Subject: Additional Information Regarding Commonwealth Edison Company's  
Request to Increase the Steam Generator Tube Interim Plugging Criteria  
for:

Byron Nuclear Power Station, Unit 1  
Facility Operating License NPF-37  
NRC Docket No. 50-454

Braidwood Nuclear Power Station, Unit 1  
Facility Operating License NPF-72  
NRC Docket No. 50-456

### Review Comments on ORNL RELAP5M3 Model of the Byron/Braidwood D4 SG

Test8z DP across P-TSP

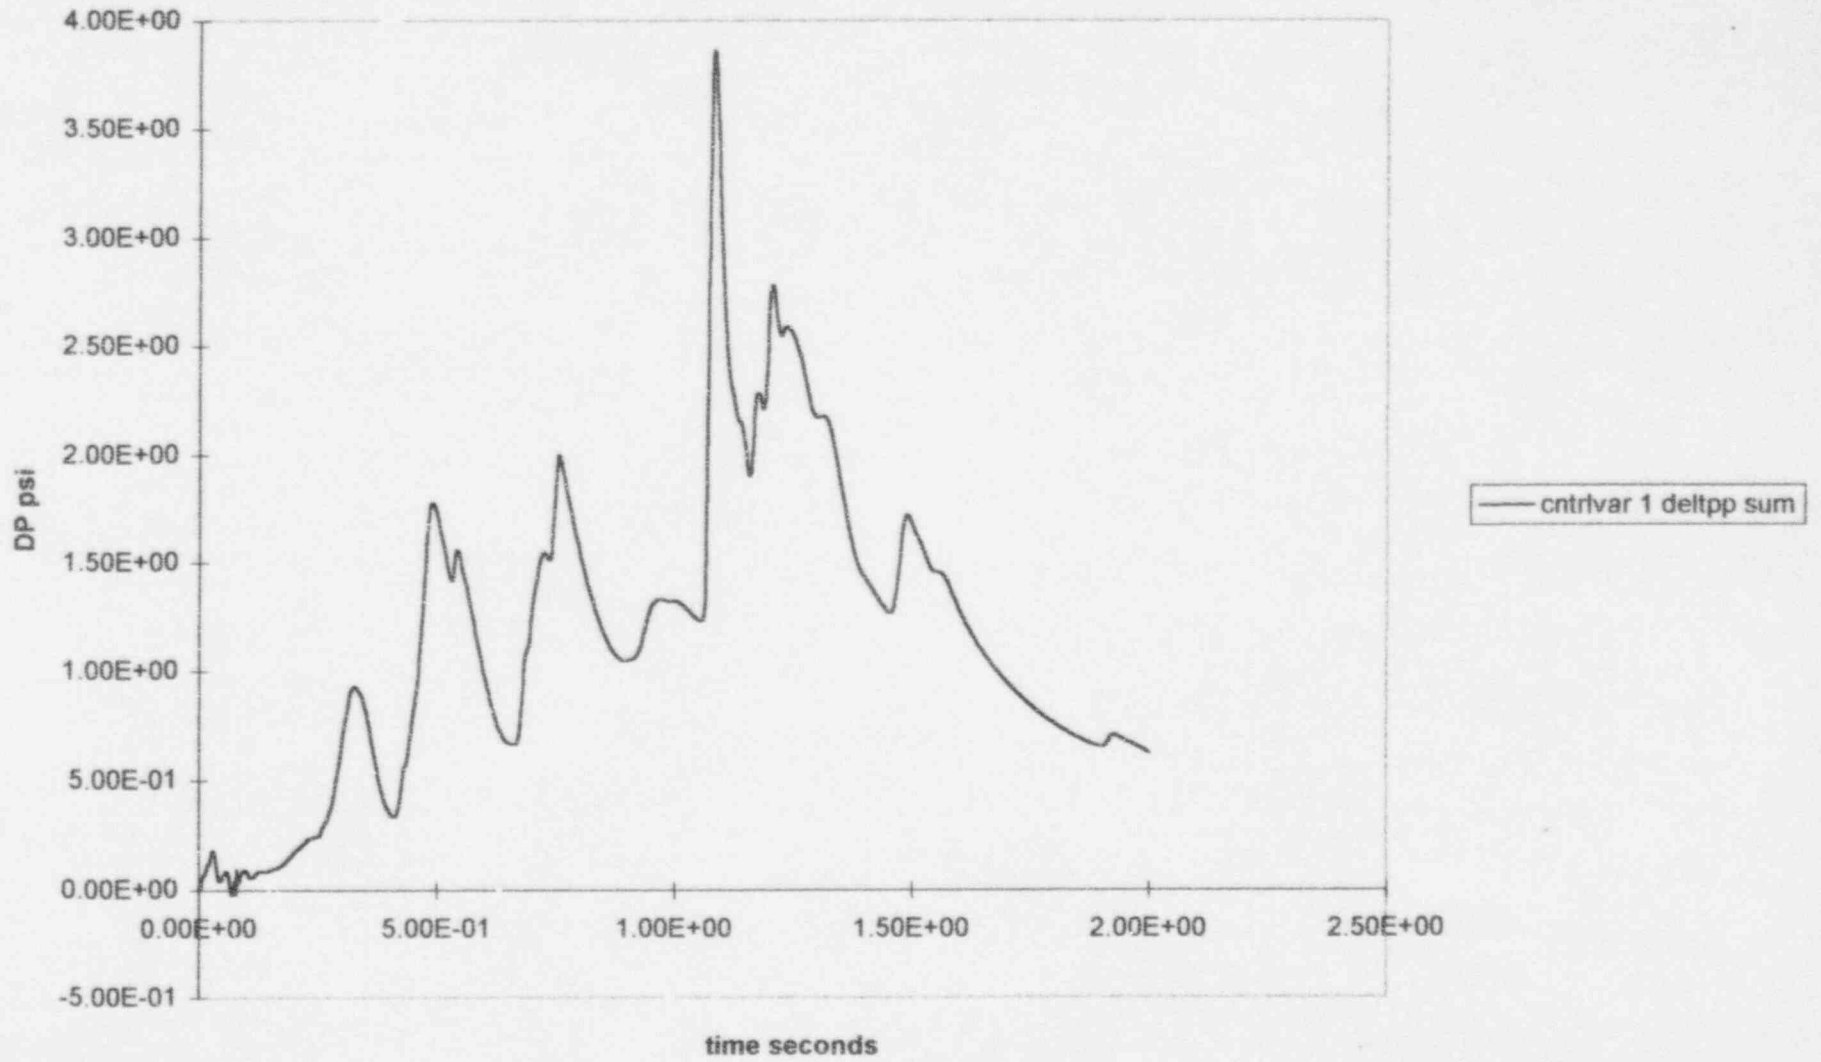
Two cases are presented here for information. These are cases 8z and 9z. These cases are the identical model as described above, but with time steps of 0.0005 and 0.0001 seconds, respectively. The differential pressure predicted on P-TSP for the two cases are shown in the attached figures. It is apparent that a spike is occurring at approximately 1.1 seconds. Plots of the fluid velocity in the lower riser region are also provided. From inspection of these plots, it appears that the spike is closely related to flow reversal in the lower portion of the steam generator. The flow reversal may be resulting in discontinuous behavior relative to the interphase drag correlations and or the prediction of interphase mass transfer area, both of which could result in the numerical aberration observed. That the spike is caused by a discontinuity is reinforced by the performance of cases at differing time steps. A review of the code Models and Correlations (Volume IV) indicates that some compromises were made in the development/inclusion of interphase drag models, that may be a factor in this problem. While we are still investigating the basis of the spike, it is apparent that this value is not a significant load causing element to the TSP, if for no reason other than the very high frequency of the load.

Based on the above discussion, we would conclude that the relevant applied load on the P-TSP indicated by the RELAP5M3 model is approximately 2 to 2.5 psi. This is fairly consistent with the development of loads with other codes and calculational methods, which depending on the level of conservatism included, ranged from 1.6 to 3.7 psi. The structural calculations performed to date were based on an applied load of 3.2 psi, which bound these RELAP5M3 calculated loads in all areas except the peak "spike" still being investigated.
